Rick Hance Engineering Note

Project: Solenoid Energization, Controls, Interlocks and Quench Protection
Doc. No: H970627A

Subject: Design Review - Ground Fault Detector

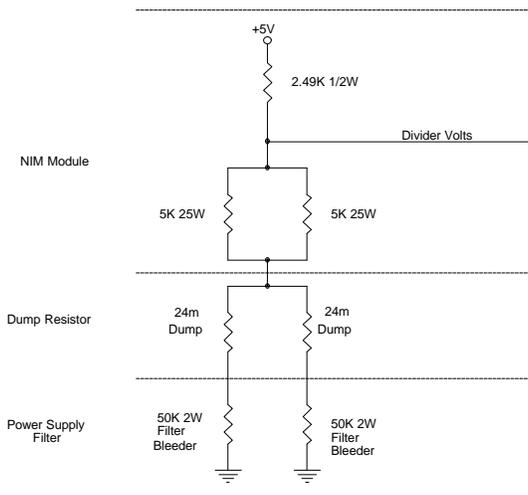
Resistance to Ground -- The resistance to ground is measured by use of a simple voltage divider. The circuit diagram below shows the elements and values of the voltage divider:

The "divider voltage" represents the resistance to ground "seen" by the comparators. This voltage is buffered and routed to the control system (Buf Gnd Sense) for remote monitoring, and compared to high and low limits on this module for determination of the gnd fault interlock status. The divider voltage is interpreted as follows:

The solenoid power supply filter contains bleeder resistors which combine to provide 25k Ohms to ground. Thus this module should never "see" more than 25k Ohms -- and it will open the interlock if it does. This "upper limit" is adjustable on the module with a variable resistor over a range of slightly less than 25k Ohms to infinity. The lower limit is also adjustable on the module with a variable resistor over a range of 2.5k Ohms to infinity. The lower limit setting is monitored by the control system which will expose any hanky panky with the adjustment in order to "override" a low ground resistance.
